# HISTORIC AND DESIGN REVIEW COMMISSION

April 01, 2015

**HDRC CASE NO:** 2015-117  
**ADDRESS:** 902 N PINE ST  
**LEGAL DESCRIPTION:** NCB 1653 BLK A LOT W 115.23 FT OF 8 ARB A8  
**ZONING:** R5 H  
**CITY COUNCIL DIST.:** 2  
**DISTRICT:** Dignowity Hill Historic District  
**APPLICANT:** Lewis McNeel/Candelilla, LLC  
**OWNER:** Lewis McNeel/Candelilla, LLC  
**TYPE OF WORK:** Historic Tax Certification, Exterior Repairs and Modifications  
**REQUEST:**

The applicant is requesting a Certificate of Appropriateness for approval to:

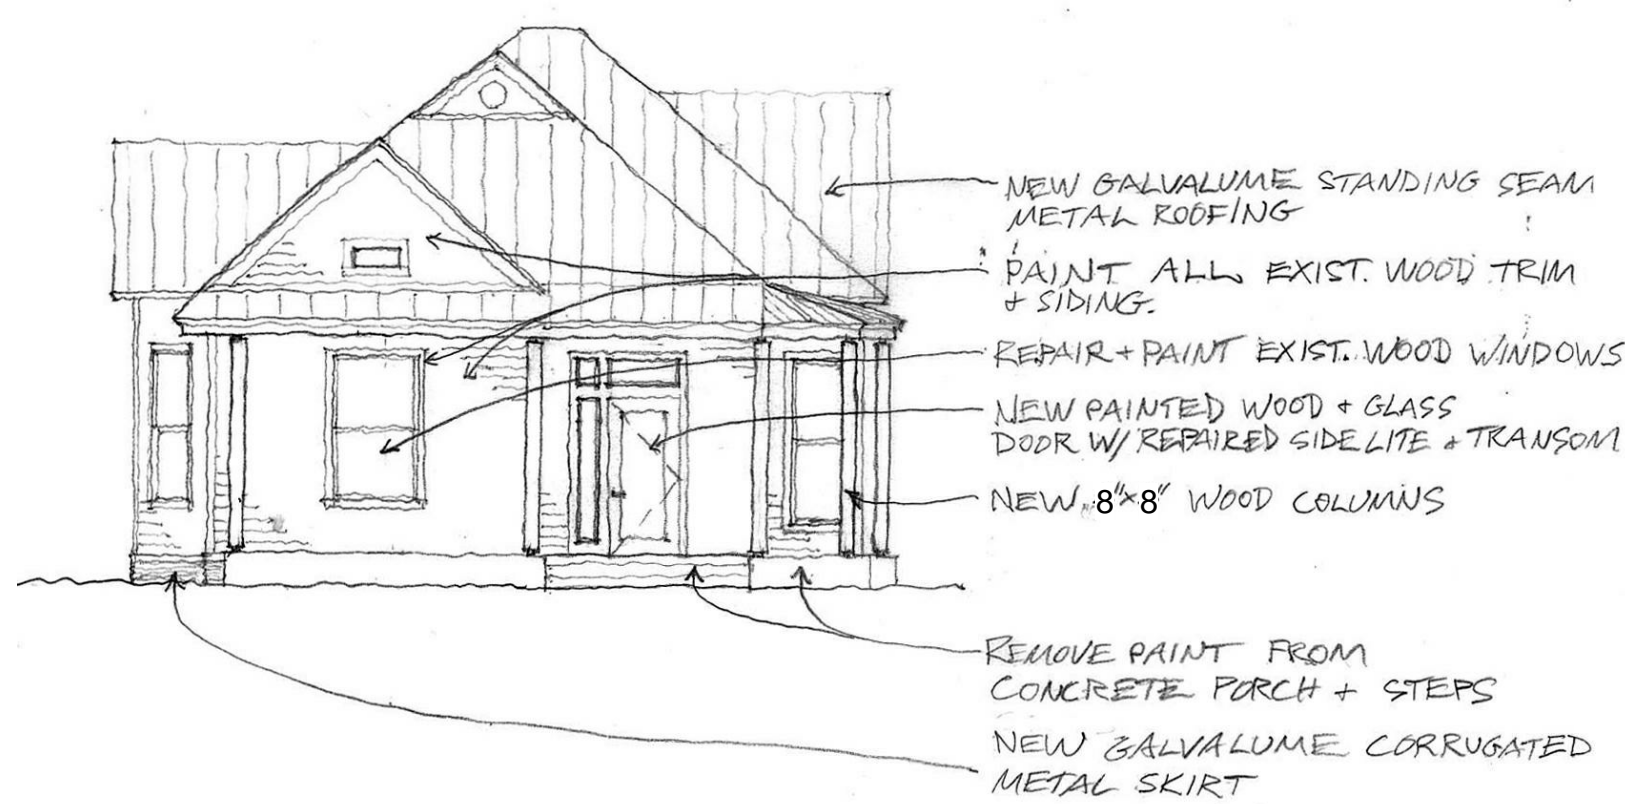
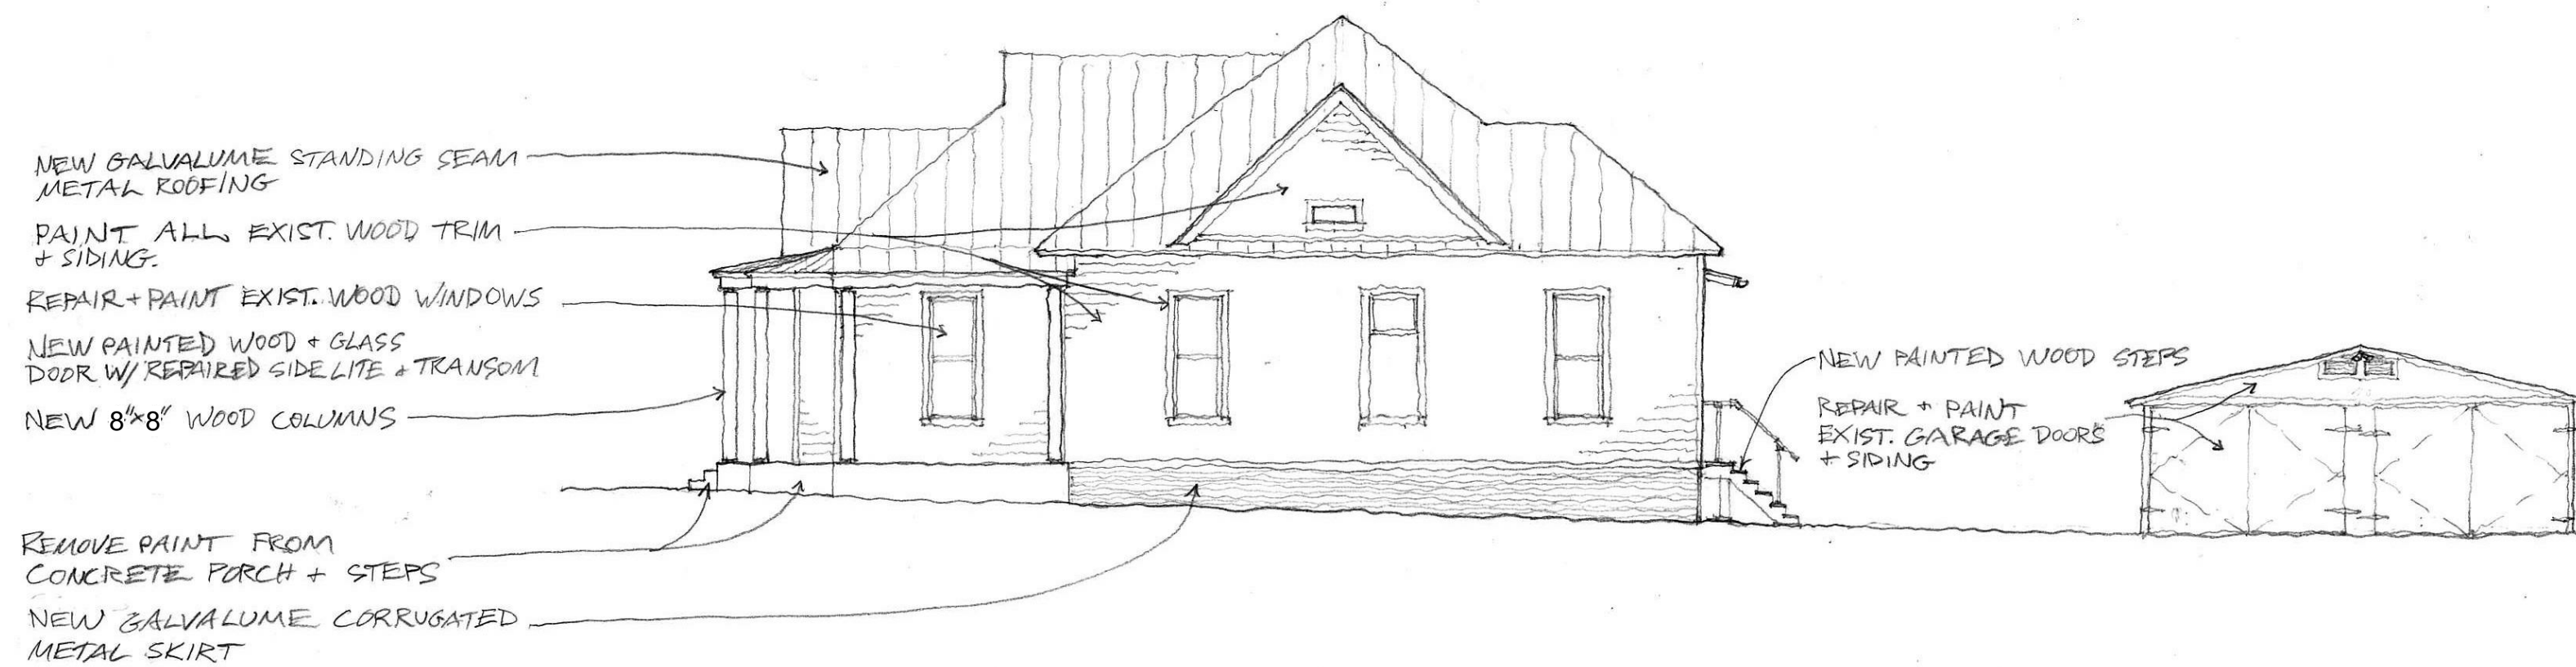
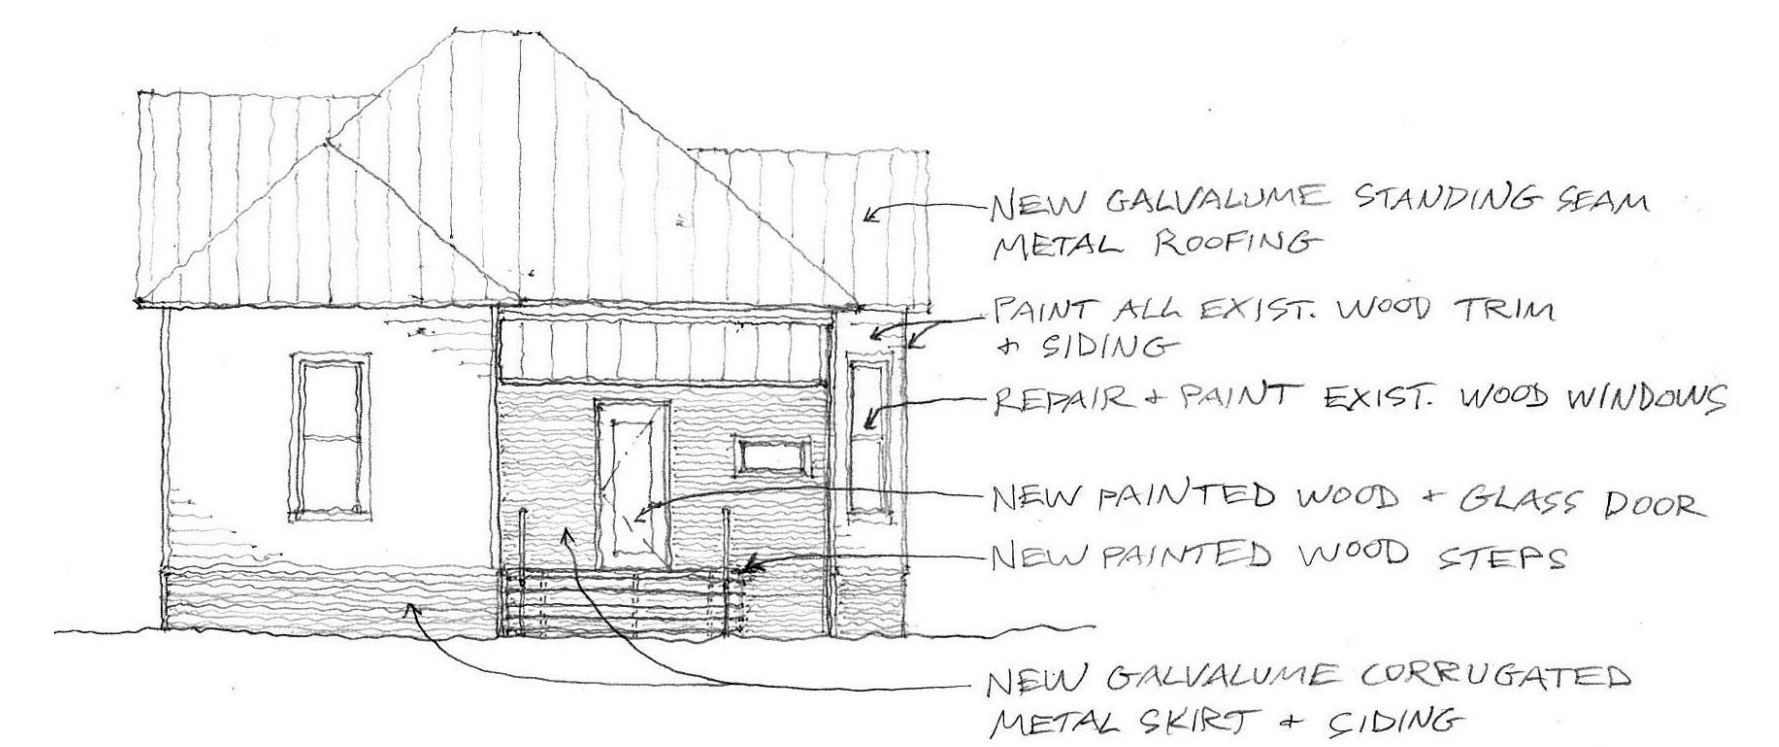
- a. The house at 902 North Pine was built ca. 1905 in the Folk Victorian style.
- b. Consistent with the Guidelines for Exterior Maintenance and Alterations, a non-historic door should be replaced with a new door that matches the architectural style of the building. Although replacement of the non-historic metal doors may be appropriate, the proposed door has a Craftsman style which does not match the style of the house. A replacement wood door with a simple oval or rectangular lite would be more appropriate.

- d. Replacement skirting should consist of durable, proven materials, and should either match the siding or be applied to have minimal impact as recommended by the Guidelines for Exterior Maintenance and Alterations. The proposed corrugated metal skirting is not a commonly used skirting material in historic residential structures and its installation will significantly impact the structure. Wood siding to match existing would be a more appropriate skirting material.

- e. Consistent with the Guidelines for Additions, materials that match in type, color, and texture should be used. Any new materials introduced to the site as a result of an addition must be compatible with the architectural style and materials of the original structure. The proposed corrugated metal is not compatible with the existing materials on the house or is a commonly found cladding material in residential structures within the Dignowity Hill Historic District. Its installation, which will be visible from the street, will cause an adverse effect to the historic structure. Wood siding with a different profile from the existing would be a more appropriate cladding material.

1. Staff does not recommend approval of item 1 as submitted based on finding a-b. Staff recommends that the doors are replaced with an appropriate style door.
2. Staff recommends approval of item 2 as submitted.
3. Staff does not recommend approval of item 3 as submitted based on findings d-e. Staff recommends wood siding is used.
4. Staff recommends approval of item 4 as submitted.
